Our Ref: STH17/00220/45

Your Ref: PP-2021-837 (55387E/4)

**PLANNING PROPOSAL 2021-837 – MOSS VALE ROAD NORTH URBAN RELEASE AREA
PLANNING PROPOSAL AND DRAFT DEVELOPMENT CONTROL PLAN CHAPTER– PUBLIC
EXHIBITION**

Planning Proposal
Proposed LZN Changes

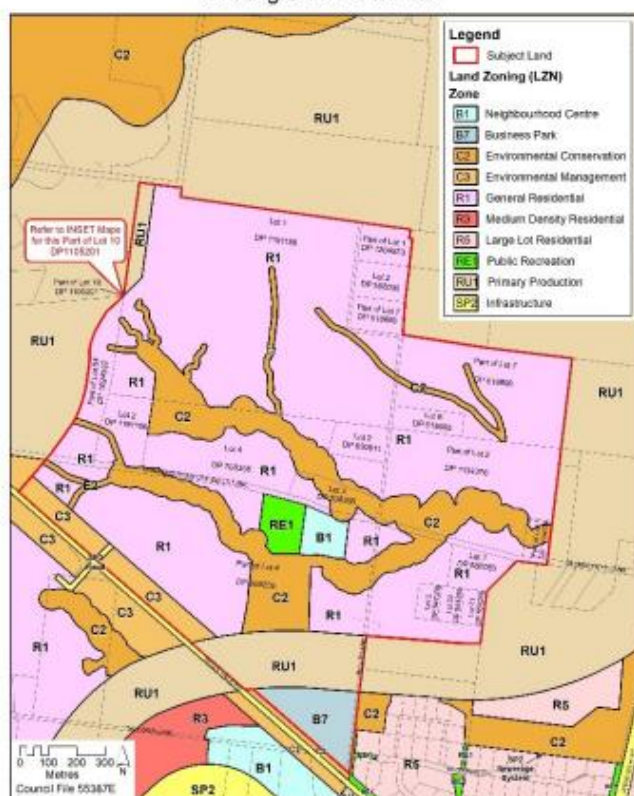
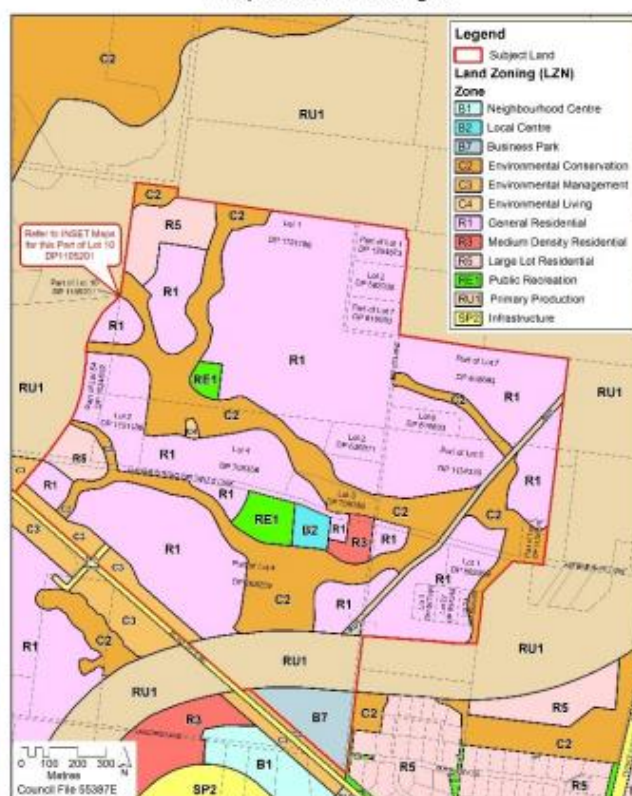
4. *Reduction in C3 Environmental Management zone:* TfNSW notes that the proposal seeks to rezone a portion of the existing C3 Environmental Management zoned land adjacent to Moss Vale Road in Lot 4 DP 268209 to R1 General Residential zoned land (i.e. a reduction from a 75m width to a 45m width). The width of the proposed C3 zone land has been determined, in part, based on a Visual Impact Assessment.

at this time, has been to the east of Bells Lane, Moss Vale Road, and Far North Collector Road intersection and noting that it has no current plans for upgrades to the west of Bells Lane along the Moss Vale Road frontage of the MVRN URA site, TfNSW is supportive of the preservation of land within the C3 zoned portion until a clear understanding of what future upgrades is known. The PP should ensure sufficient land is preserved to enable the future widening of Moss Vale Road if and when required.

TfNSW does note that the Visual Impact Assessment prepared by Allen Price & Scarratts Pty Ltd and dated 5 April 2019 does not factor in any future upgrade works and widening of Moss Vale Road. As such, it has not included an assessment of the impact the widening of Moss Vale Road would have on the visual quality of the URA as viewed from Moss Vale Road. If this area is to be vegetated as part of a landscape corridor, future road works such as the widening of Moss Vale Road could have an impact on this landscape corridor.

In adopting a setback Council should be satisfied that sufficient land is preserved free of any encumbrances such as new vegetation buffers to enable the provision of a visual buffer so as to not limit the ability for improvement works to be undertaken. In this regard, TfNSW requests that any future local road infrastructure associated with the subdivision of Lot 4 DP 268209 as part of the MVRN URA be wholly located within the R1 zoned land and not encroach into the C3 zoned land.
